RE: Seeley Reservoir Stockpiles, File No. # M-2023-043, New 112c Application, Adequacy Review-1

RE: Seeley Reservoir Stockpiles, File No. M-2023-043 (Adequacy Review/Additional Application Comments)

SEELEY RESERVOIR SEDIMENT BASIN CONSTRUCTION DRAWINGS

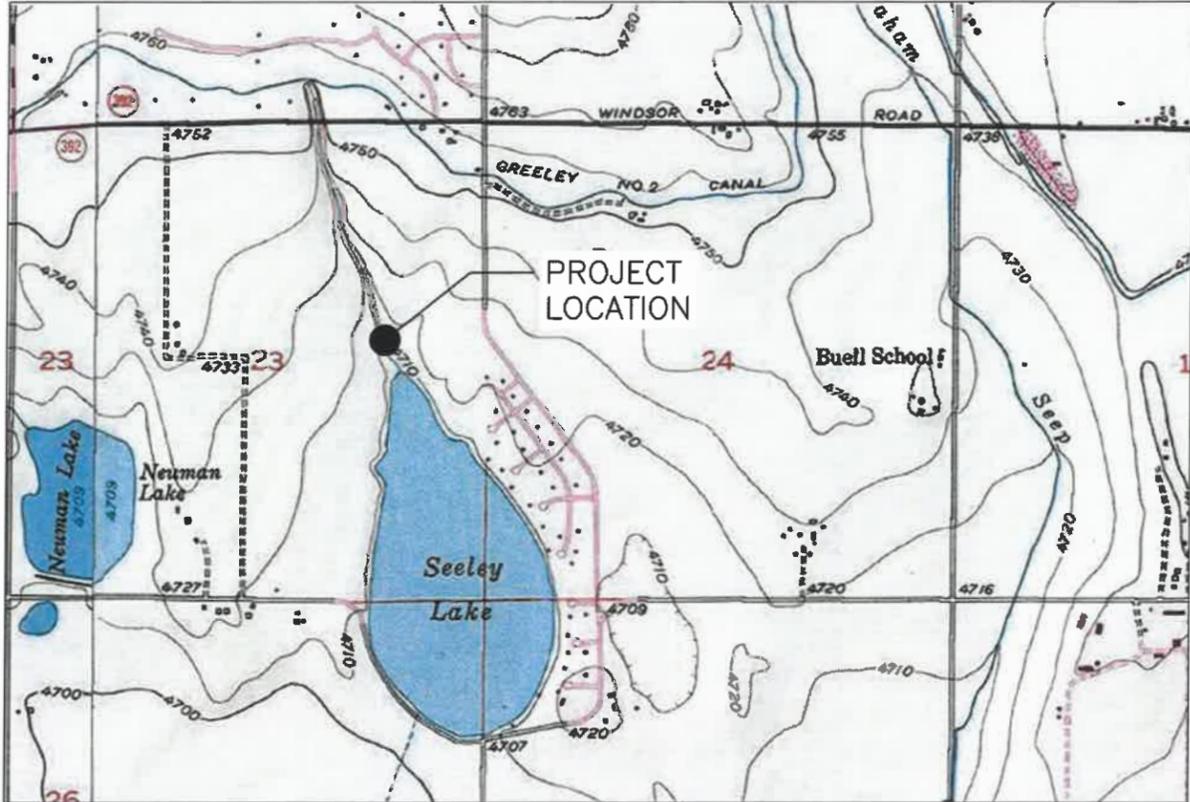
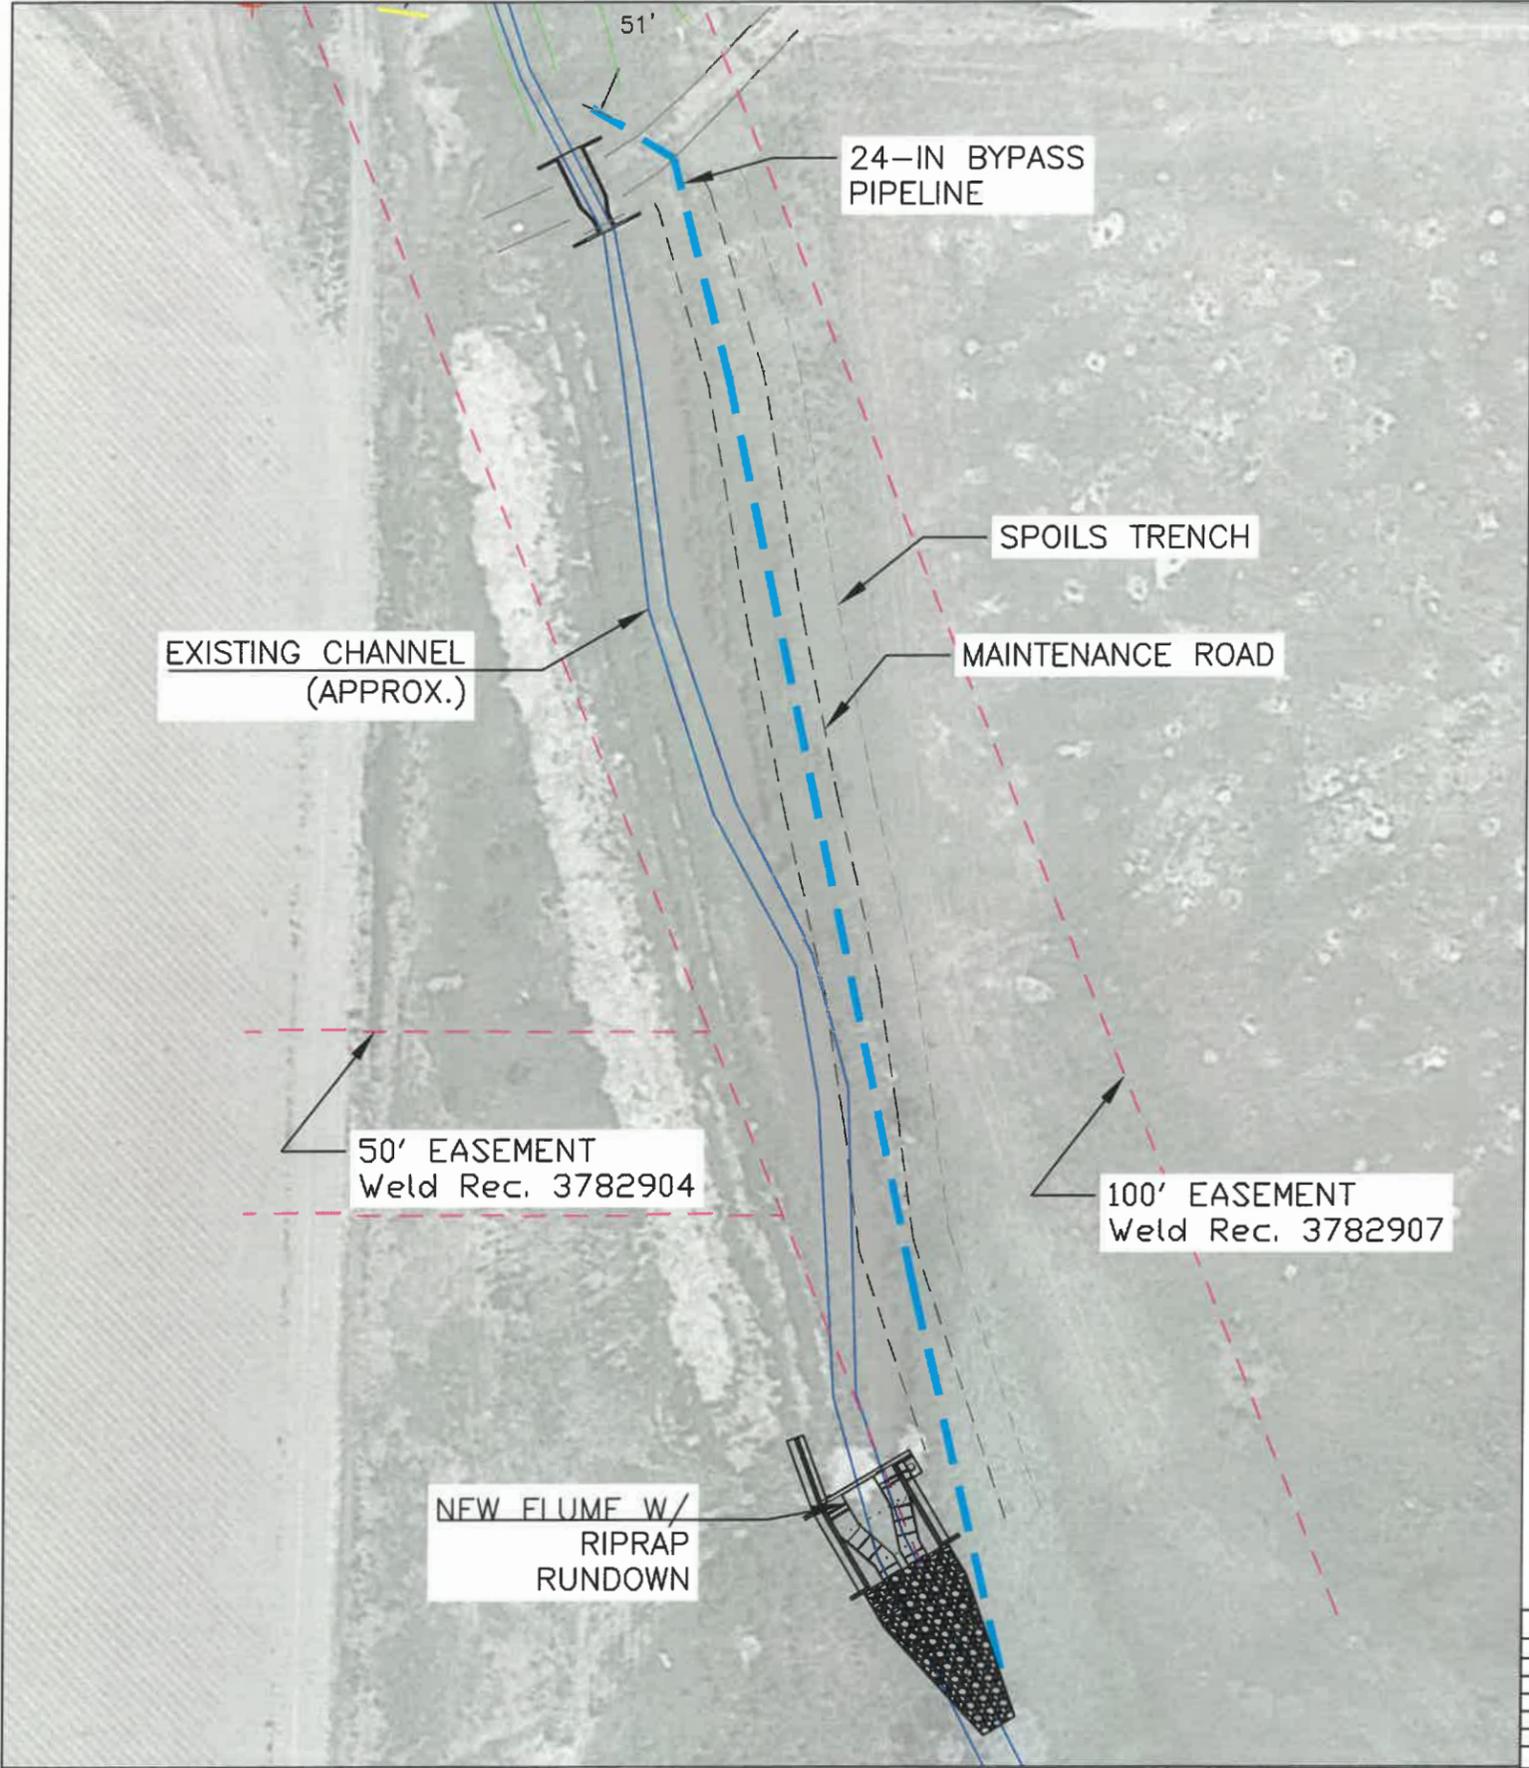
1. Please see the image below, highlighting an emergency spillway that would have a detrimental impact to our property and was built in conjunction with the structure impacting our properties. I have also included via "Attachment B" the retroactively stamped plans related to this structure/area of concern noted in previous comments.
